COLORADO DEPARTMENT OF TRANSPORTATION
REGION 4
10601 West 10th Street
Greeley, CO 80634

Summary Observations

An on-site ADA survey was conducted November 25, 2016, by Patrick Going, ADA Consultant. All observations are based on the *2010 ADA Standards for Accessible Design*. These Standards may be found at www.access-board.gov.

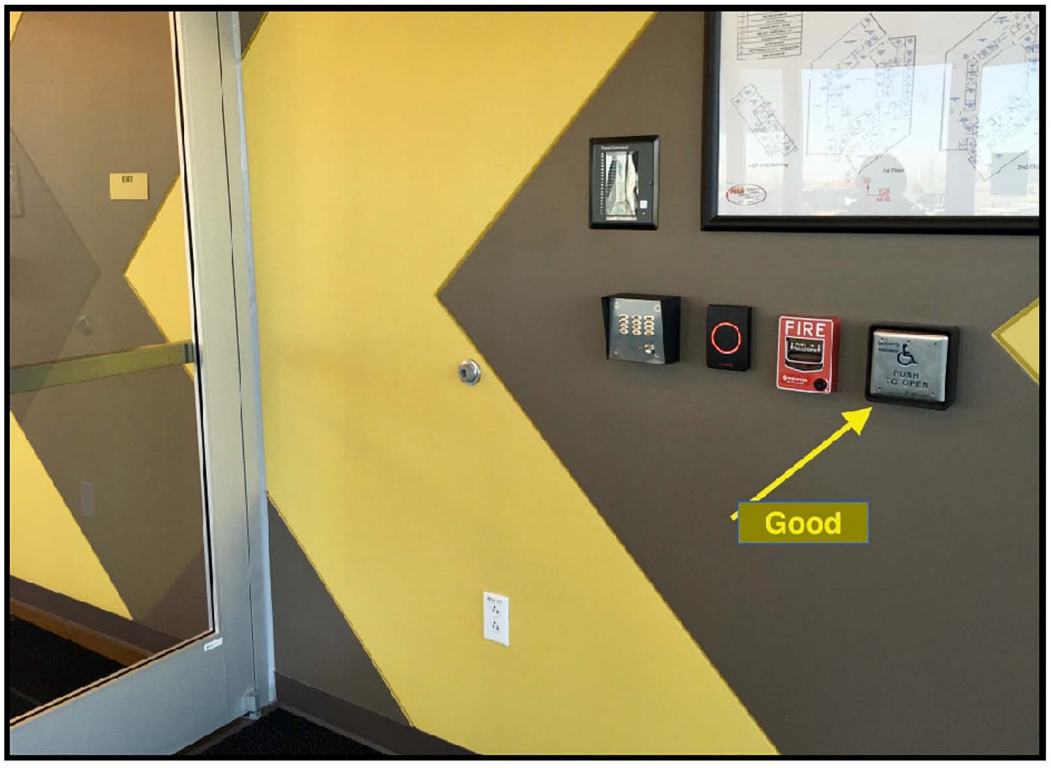
Power assist entrance door
TRASH
MIXED RECYCLABLES
Recommend moving bin 2' left for clear floor space at door activation pad

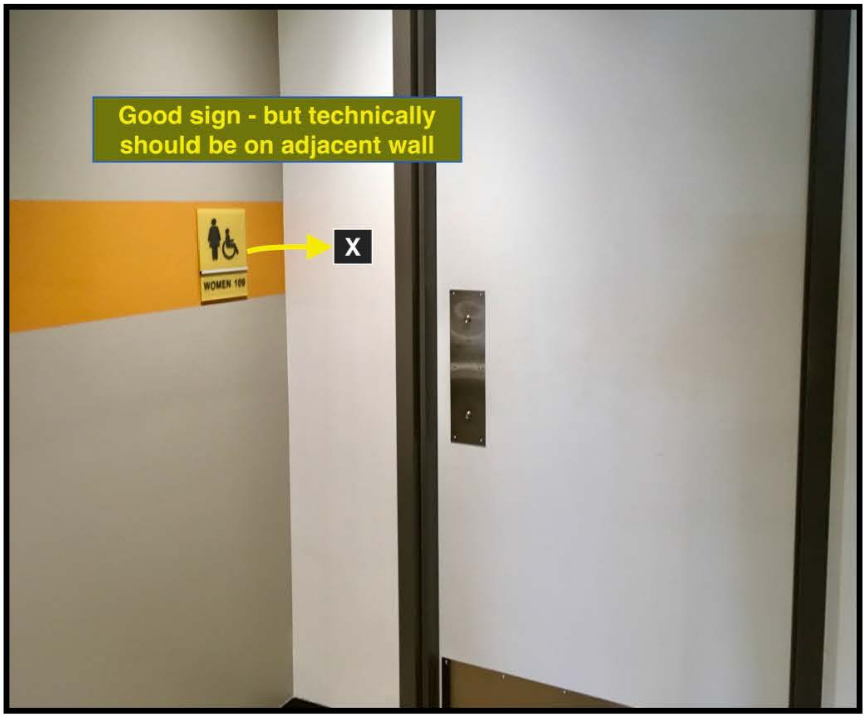
Better to put sign on wall on latch side of door
X
MEN 108

Good sign - but technically should be on adjacent wall
X
WOMEN 109

Recommendations	
Description	**Priority**
Add a'van' sign to two of the vertical posts designating accessible parking spaces.	Immediate
Reduce interior opening door pressure to 5 lbs at the two public restrooms and conference room	Immediate
Relocate or add restroom signs next to door - see picture below	Soon
